Access Compliance Report Public Rights-of-Way (Curb Ramps)

Main Street: THISTLE_RD Cross Street: THERESA_AVE Location: N

ADA ID: RPRK210924174125 Ramp Type: Type 6 - Directional 1 Initial Pass/Fail: Fail Overall Compliance: No Severity Score: 15

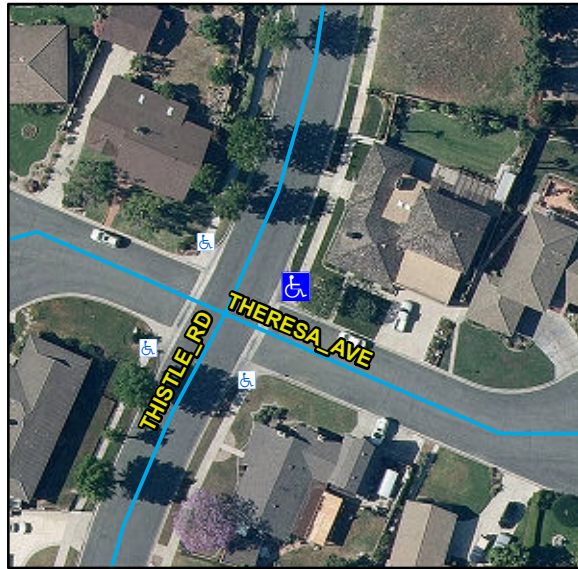
Compliance	Description	Data	Compliance	Description	Data
N/A	Ramp Length (in)	82	N/A	Flare Type LT	
Yes	Ramp Width (in)	60			N/A
No	Ramp Run Slope (%)	8.8	N/A	Flare Slope LT (%)	N/A
Yes	Ramp Cross Slope (%)	0.2	N/A	Flare Traversable LT	N/A
N/A	Grade Break	N/A	N/A	Flare Type RT	
N/A	Grade Break Slope (%)	N/A			N/A
N/A	Grade Break Cross Slope (%)	N/A	N/A	Flare Slope RT (%)	N/A
	Addl Para Ramp Left?	No	N/A	Flare Traversable RT	N/A
	Addl Para Ramp Right?	No	N/A	DWS Provided	N/A
N/A	Landing Present	N/A	N/A	DWS Contrast	N/A
N/A	Landing Length (in)	N/A	N/A	DWS Length (in)	N/A
N/A	Landing Width (in)	N/A	N/A	DWS Full Width	N/A
N/A	Landing Run Slope (%)	N/A		DWS Offset Type	N/A
N/A	Landing Cross Slope (%)	N/A	N/A	DWS Left Offset (in)	N/A
N/A	Landing Movement Obstructed?	N/A	N/A	DWS Right Offset (in)	N/A
	Landing Movement Type	N/A			
N/A	Landing Shared	N/A			
N/A	Marked Crosswalk 1	No	N/A	Clear Space	Yes
	Crossing 1 Direction	W	N/A	Clear Space To Crosswalk (in)	N/A

Marked Crosswalk 1 Width (in)	N/A			
N/A	Ramp Inside Crosswalk 1	N/A			
	Crossing 1 Slope (%)	4.7			
	Crossing 1 Cross Slope (%)	0.9			
N/A	Gutter Ponding	N/A	N/A	Curb Slope	8
Yes	Gutter Lip Height (in)	0		Road Run Slope (%)	1.3
N/A	Gutter Run Slope (%)	N/A		Road Cross Slope (%)	4.7
N/A	Gutter Cross Slope (%)	N/A		Parallel Ramp Side	Right
Yes	Overall Surface Condition	Acceptable	Yes	Perp Joint Present	Yes
	Cross Gutter Present?	Yes		Spandrel Present?	Yes
	Replace Cross Gutter?	No		Replace Spandrel?	No

Remove & Replace Curb Ramp With Two New Directional Ramps or Equivalent.
